Subject: DIFFERING PROFESSIONAL OPINION ON STEAM GENERATOR TUBE
 INTEGRITY

Voltage-Based Alternative Repair Criteria

**A Report to the Advisory Committee on Reactor Safeguards
by the
Ad Hoc Subcommittee on a Differing Professional Opinion**

Figure 3. Schematic Diagram of Natural Circulation in the Primary Reactor Coolant System. On the left, full loop natural circulation is shown. On the right, countercurrent natural circulation through the steam generator is shown.

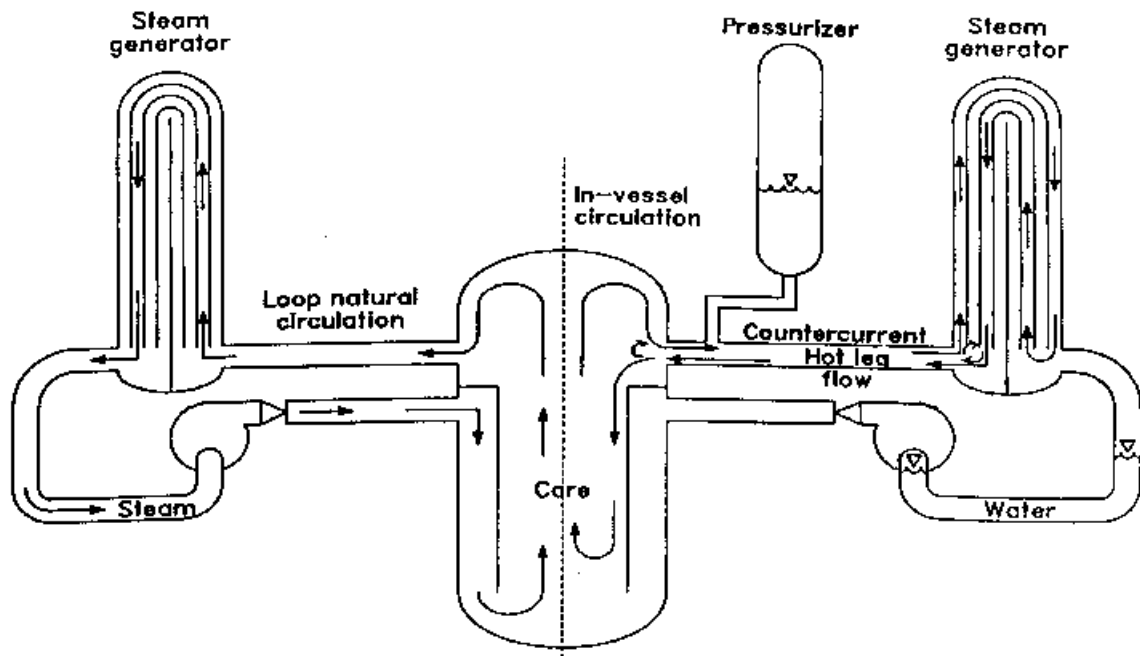
The staff has analyzed the possible evolution of severe accidents and the loads that they place on the steam generator tubes using computer models like SCDAP-RELAP5. These analyses [5] are predicated on the assumption that the “loop-seals” in the primary reactor coolant system remain in place, so there is not a gross convection through the reactor coolant system³. Instead, a countercurrent natural circulation of steam from the degrading reactor core through the steam generator tubes and back to the core is established. A schematic diagram of this natural circulation flow is shown in Figure 3. The analyses done by the staff indicate that heat is transferred to other parts of the primary reactor coolant system by the natural circulation flow, and failure at other locations is likely to occur before a steam generator tube undergoes gross failure as a result of creep rupture. Typically, the surge line is predicted to fail first, followed by failure of a reactor nozzle. The analyses also show that the timing of the failures at the various locations are not greatly different.

³ If a loop seal is opened and the coolant level in the pressure vessel is sufficiently low, an overall natural circulation of high-temperature steam through the steam generator and back into the vessel develops (see the left side of Figure 3.) This overall natural circulation is thought to impose sufficiently high heat loads on the steam generator tubes that the tubes fail whether they are flawed or not. Detailed analyses have not been done, but it is known that additional complexities can develop in the analyses of such scenarios, including episodic re-establishment of the loop seals.

The Ad Hoc Subcommittee concluded that the issue of the possible evolution of severe accidents to involve gross failure of steam generator tubes and bypass of the containment is not yet resolved. The Subcommittee also believes that the issue needs consideration regardless of the criteria adopted for the repair and replacement of steam generator tubes. The issue may be affected by any enhanced leakage that comes from the use of the alternative repair criteria described in GL 95-05. But, the issue is just one of several significant uncertainties that now exist in the assessment of severe accident progression.

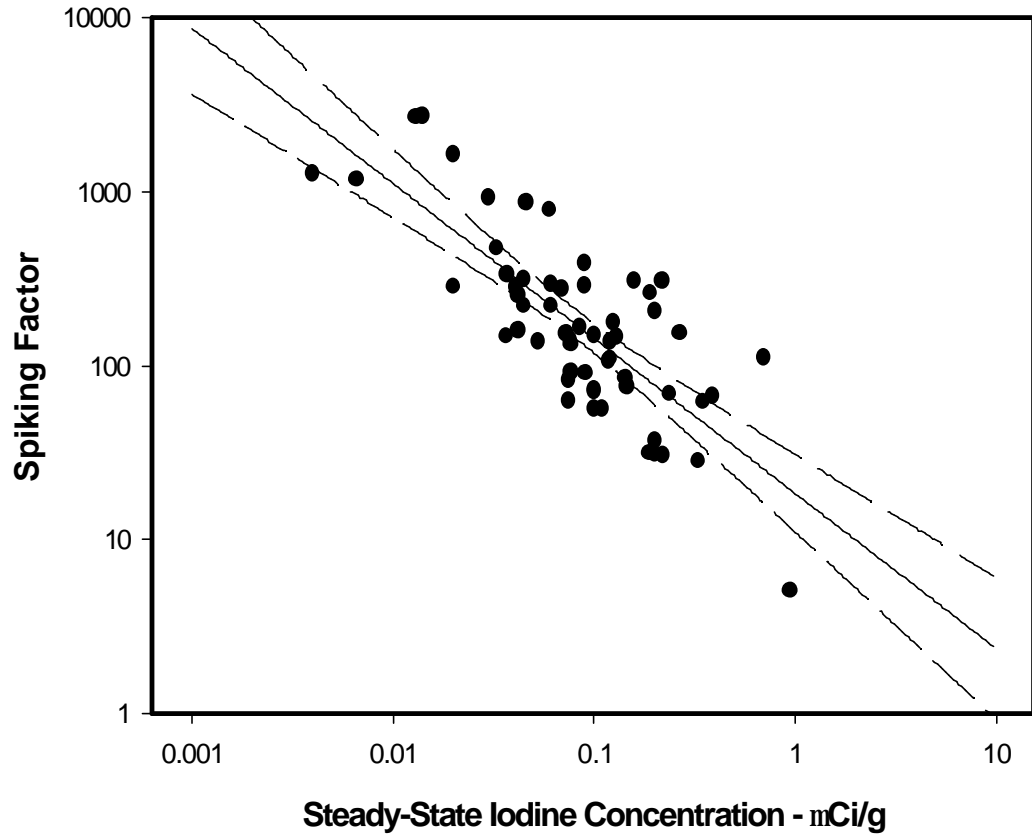
by the DPO author (See Figure 6). A phenomenological understanding of this correlation between the iodine spiking factor and the steady-state iodine concentration in the coolant is not well established.

The DPO author rightly contends that the iodine spiking factor seems to exhibit a correlation with the initial iodine concentration in the coolant. But, it might be argued that for accident analyses the appropriate spiking factor to use is that found from the empirical correlation using the actual operational iodine concentration rather than the Technical Specifications limit adopted by the licensee, whether it is 1.0 $\mu\text{Ci/g}$ or 0.01 $\mu\text{Ci/g}$. Such a procedure would be inconsistent with the approaches that have long been used in the analysis of design basis accidents. The Ad Hoc Subcommittee also believes that the empirical, linear correlation of spiking factor with initial iodine concentration to the very low initial iodine concentrations typical of many plants today without explicitly accounting for data uncertainties and variations in the mechanisms that lead to operational levels of iodine in the coolant is without sound technical foundation.

Data are available to develop a correlation of the spiking factor with steady-state iodine concentration for analysis of steam generator tube rupture events. If this is done, the correlation should be used with whatever Technical Specification limit on the iodine concentration has been adopted by a licensee rather than the operating iodine concentration typical of the plant. This will maintain consistency with

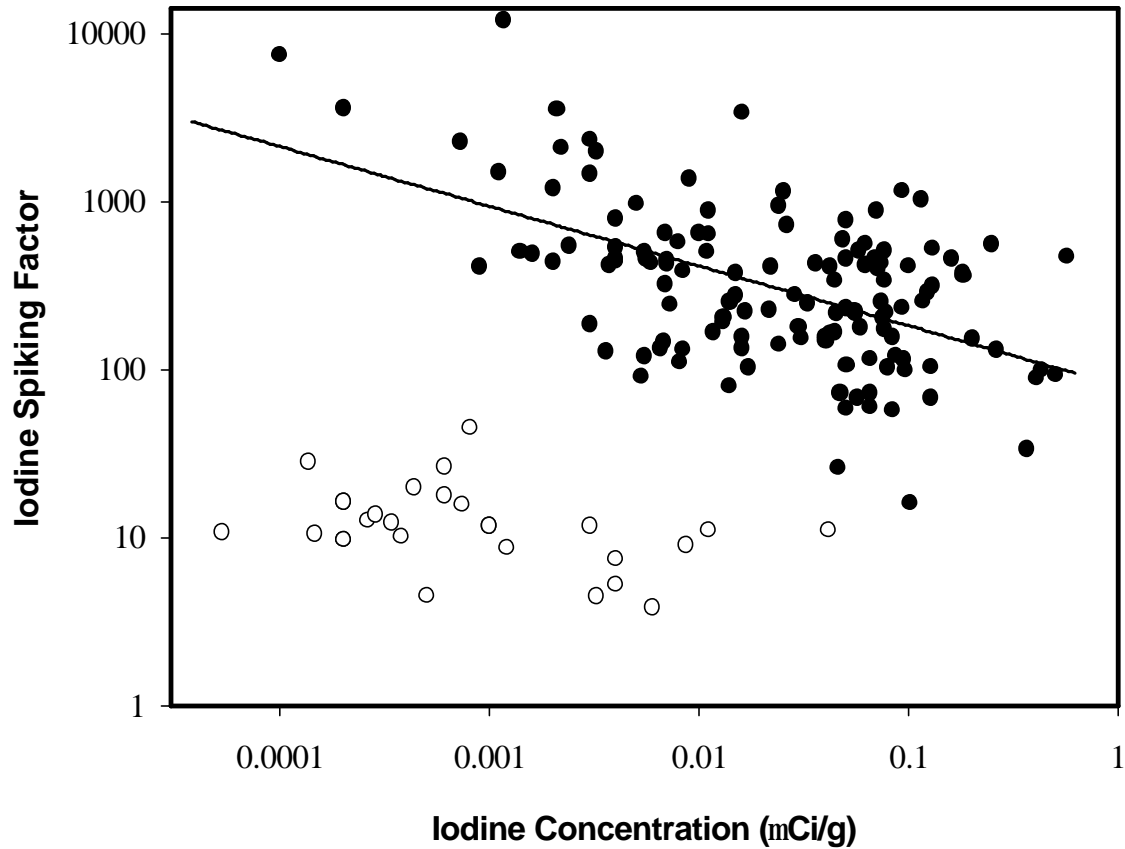
The staff provided the Ad Hoc Subcommittee with an expanded data set on spiking factors. The pedigree of this database is uncertain, but it definitely is not the database used to prepare plots of spiking factor as a function of the initial, steady-state iodine concentration of the coolant shown to the Subcommittee and included in the staff's responses to the DPO. This database seems to be composed of two populations (See figure 7). In one population, the spiking factor does exhibit a dependence on the initial, steady-state iodine concentration. Spiking factors from the other population appear to be
